July 11, 2016

This letter is written in response to your emails, dated May 18, 2016, referenced below, wherein you have asked several questions regarding how the NRC Staff interprets / implements Tier 2*. The NRC Staff's response is set forth below.

Figure 3H.5-3

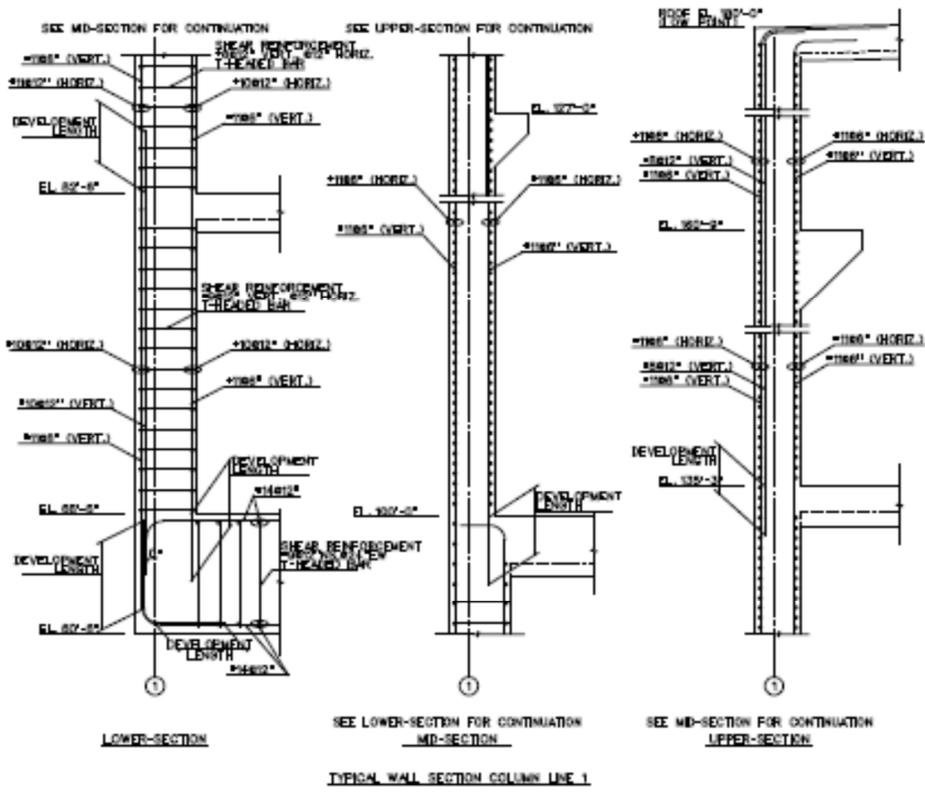
A good example is DCD Figure 3H.5-3 and the language that references that figure. Westinghouse changed the design from what is depicted in Figure 3H.5-3 (at the MSE wall) in order to mitigate potential rebar congestion. Westinghouse asserted at that time that the re-design met ACI 349 and therefore was consistent with the DCD design basis. Regardless of that figure's Tier 2 designation Westinghouse asserted that no License Amendment Request was necessary. NRC Staff disagreed with Westinghouse's interpretation of DCD design adherence and required a License Amendment Request to change the design. As a result of this event I believe NRC communicated to Southern Nuclear that strict adherence to the designs as shown in the DCD is required. Ultimately, the installed rebar was reconfigured to match the design as shown in the DCD. It's actually this event that is driving my questions.*

Next, let me address the example you provided. The NRC staff cannot verify the statements that you made with regard to staff positions, however, the AP1000 DCD Figure 3H.5-3, is clearly marked in a way that indicates that all of the information contained in the figure is Tier 2* information, and therefore, subject to the requirements of the rule regarding changes to Tier 2* information. There is additional text in the AP1000 DCD, Appendix H, Section 3H.5, that indicates that "typical wall reinforcement" is shown in Figure 3H.5-3 (enclosed) and is entirely Tier 2*.
